From: [GLORIOSO-MOSS , ROMELLA S.](#)
To: ramonlorenzomartinez@gmail.com
Cc: [GARCIA, MICHAEL J.](#); [Gary Schiffmiller](#); toddcanon@yahoo.com; chandler.tmoore@gmail.com; [Mark Brooks](#); [KEELIN, KODY W.](#)
Subject: FW: Request for BPAC Agenda Item – Guadalupe Street Project Concerns
Date: Wednesday, October 1, 2025 9:28:00 PM
Attachments: [image.png](#)
Importance: High

I am requesting an agenda item at the upcoming BPAC meeting to address serious concerns about the Guadalupe Street reconstruction project.

I have attached photos from the original plans that show:

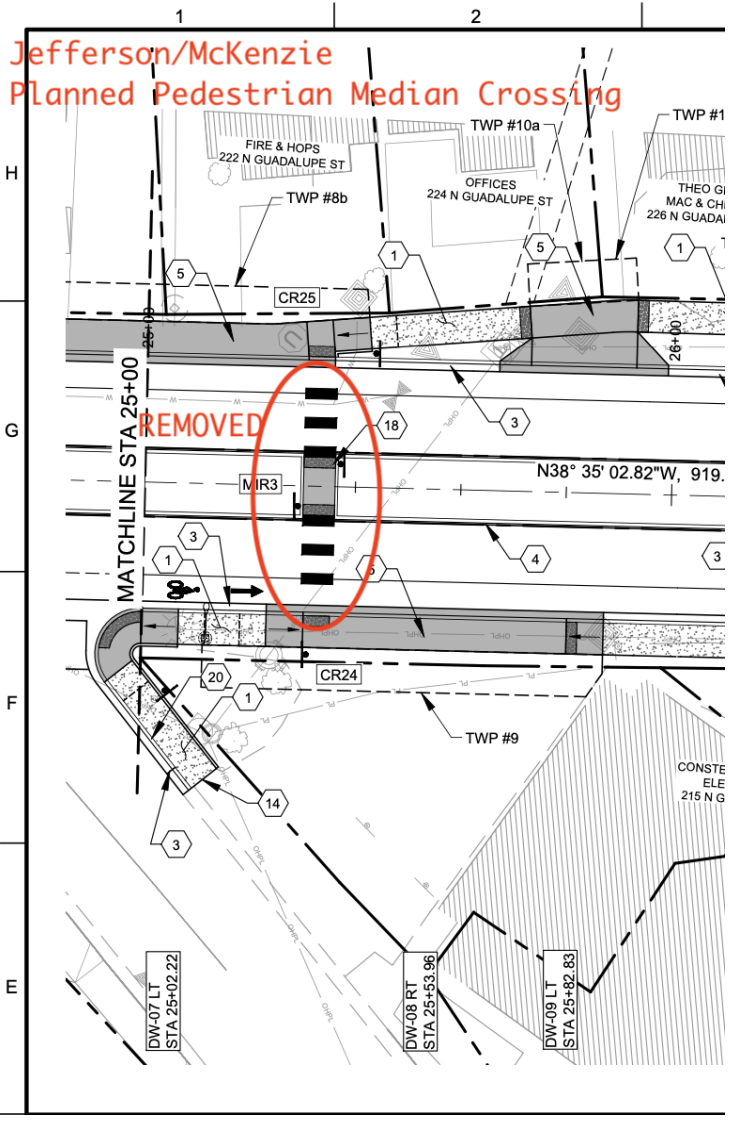
- The planned pedestrian median crossings at Jefferson and McKenzie, now removed. Kody Keelin, City Of Santa Fe Project manager, Complete Streets has confirmed this was done without notifying the public and due to "limited room to comply with federal code" Mark Brooks: Addressed in the first bullet.
- Photos of a reworking at the Johnson St crossing. This crossing was already in place and complete, but for some reason it is being reworked right now, showing that the city is still actively working on median crossings. Mark Brooks: Was done to bring it into compliance.
- Photos of the removal of a curb originally designed to slow vehicles for pedestrian safety, altered at the City’s request to accommodate cars or buses. Mark Brooks: was done because of traffic concerns and had no impact on pedestrian safety.

Mark Brooks: The crosswalk that Mr. Martinez is referring to would not meet compliance due to driveways on each side of the road. We looked for a solution to the problem but could not find one that meets ADA standards. NMDOT and FHWA ADA inspectors had no objections to us removing this crosswalk from the plan set. There is a controlled crossing approximately 300 feet to the north and a signed crossing about 350 feet to the south of this location.

My response: Waivers or exemptions were not sought because the proposed crosswalk location was determined to be unsafe and non-compliant with ADA standards due to physical constraints, such as driveways on both sides of the road. Waivers or exemptions are only granted when the alternative design can still meet safety and accessibility requirements. In this case, no solution was found that could meet those standards while preserving the pedestrian feature.
